AMENDMENT 1

Low-voltage fuses – Part 5: Guidance for the application of low-voltage fuses

AMENDMENT 1

This amendment corrects and adds to IEC TR 60269-5 published in 2014. This edition constitutes a technical revision.

Figure 17 – Inverter double-way connection with arm fuses
for regenerative or non-regenerative load

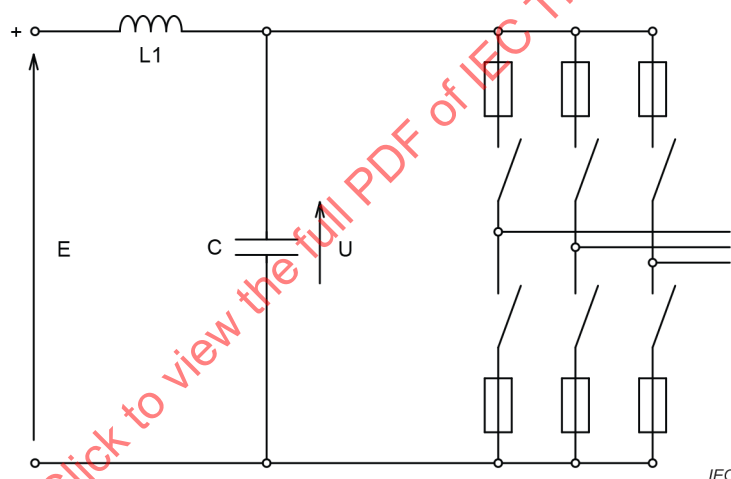
Figures 17 to 19 show examples of inverters of voltage source type.

- fuses in the arms of the inverter (Figure 17)
- fuses in the DC loop of the inverter (Figure 18): fuse current rating is $\sqrt{3}$ times the current rating of the fuse in the arms
- fuses in the DC feeder (Figure 19): between the capacitor and rectifier
- (or another kind of DC power supply)

Single inverter: The fuse-link will interrupt the capacitor discharge current generated by the short circuit created by the failure or bad triggering of semiconductors (Figure 17 and Figure 18). The fuse selection is based on the knowledge of the fuse-link maximum DC voltage rating at time constants lower than 1 ms.

Figure 19 – Multi inverters systems double-way connection with d.c. loop fuses for regenerative or non-regenerative load

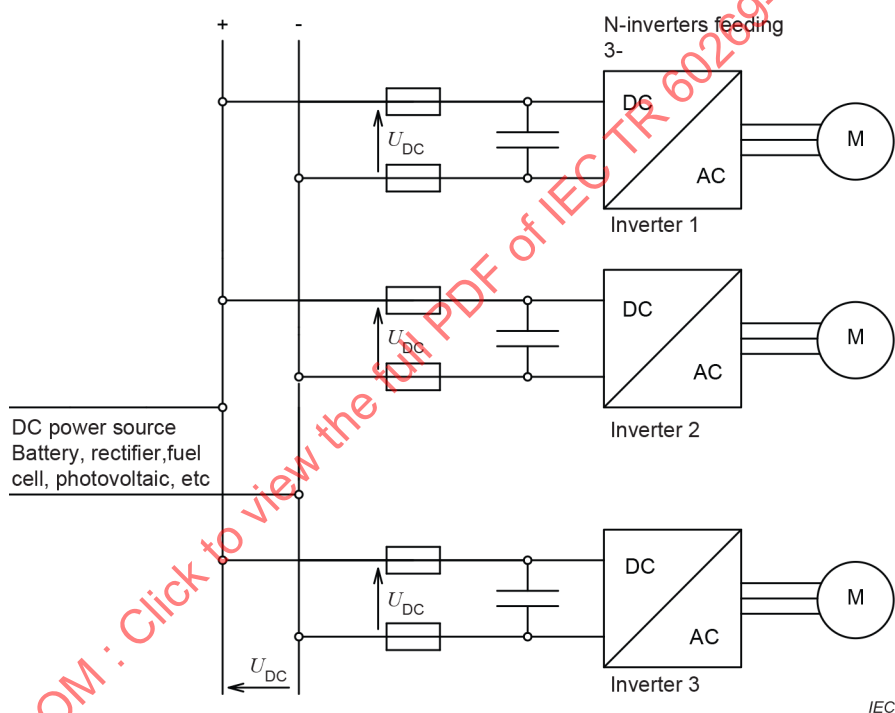
In case of multi-inverters systems (Figure 19) the fuses are installed on the DC side of each inverter and will interrupt the capacitor discharge currents from all capacitors in all other feeders (they are in parallel) and the DC current supplied by the DC power source. The fuse selection is based on the knowledge of the fuse-link maximum DC voltage rating at time constants lower than 1 ms.

Figure 20 – Capacitor discharge

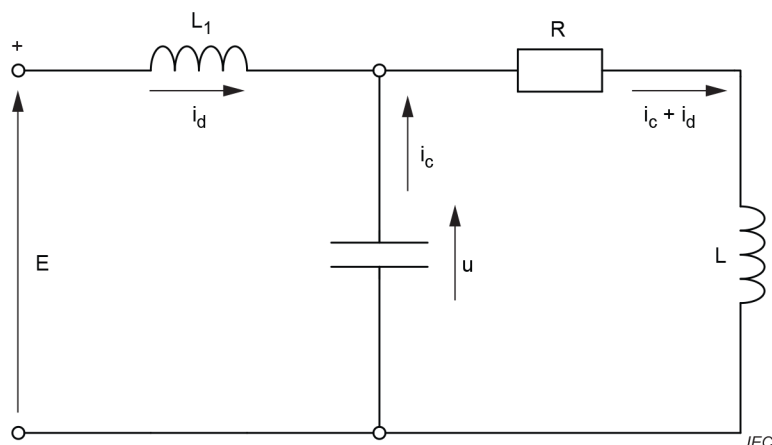
The fuse-link will operate very quickly as the di/dt is generally very high because of the very low value of the inductance L_1 (see Figure 20).

When an IGBT or a GTO fails the capacitor is short-circuited and the fuse is protecting a circuit as described in Figure 20.

- E voltage value of the DC power source-
- U instantaneous value of the voltage across the capacitor
- i_{cap} instantaneous value of the fault current supplied by the capacitor
- i_d instantaneous value of the fault current supplied by the DC power source
- L_1 total inductance of the capacitor discharge circuit
- L_2 inductance between the DC power source and the capacitor
- R resistance of the capacitor discharge circuit
- C Capacitor

Figure 21 – Voltage across the capacitor

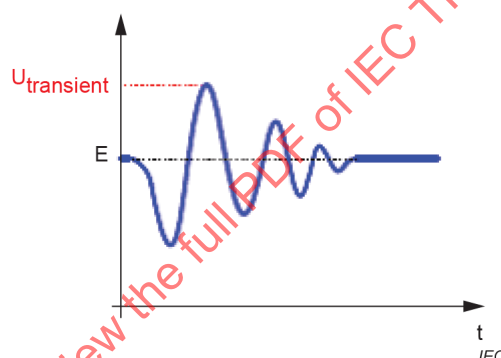
Just after the arc extinction, there is a transient phenomenon during the recharge of the capacitor by the power source producing an over voltage across the capacitor, the peak value of which is $U_{transient}$. This value is significantly above the initial value E (Figure 21).

Assuming there is no resistance in the circuit and assuming the capacitor has been fully discharged, the maximum theoretical value of this transient over-voltage is $2 E$.

The realistic value is: $U_{transient} = 1,75 E$

Figure 22 – Inductance of the circuit

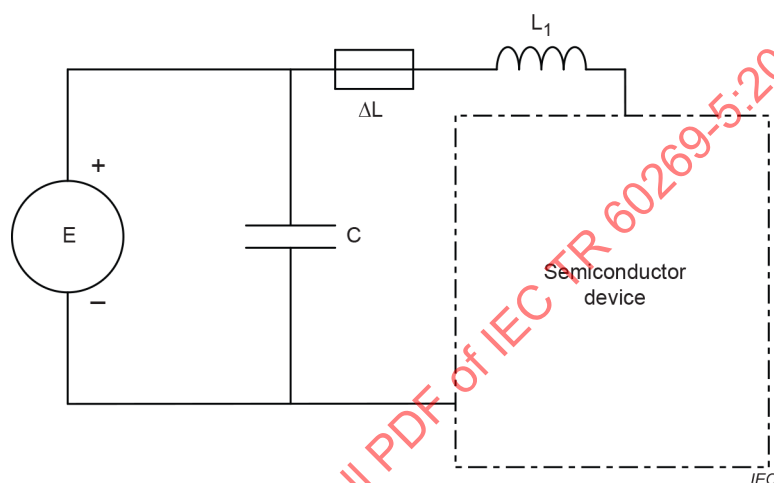
The L value of a circuit inductance depends mainly on the shape and length of the circuit. When the fuse is introduced into the circuit, it changes the length and the shape of that the circuit. Consequently the inductance L of the circuit becomes $L + \Delta L$ (Figure 22).

ΔL is not an inductance located inside the fuse having a constant value. Fuse manufacturers measured ΔL of several fuses with the circuit in Figure 22. The value of the circuit with fuse and without fuse is obtained by measuring the di/dt when the circuit is closed.

For these measurements the fuse is replaced by a copper bar in order to minimize the change of length of the circuit. The ΔL value drastically decreases when the body of the fuse is flat.
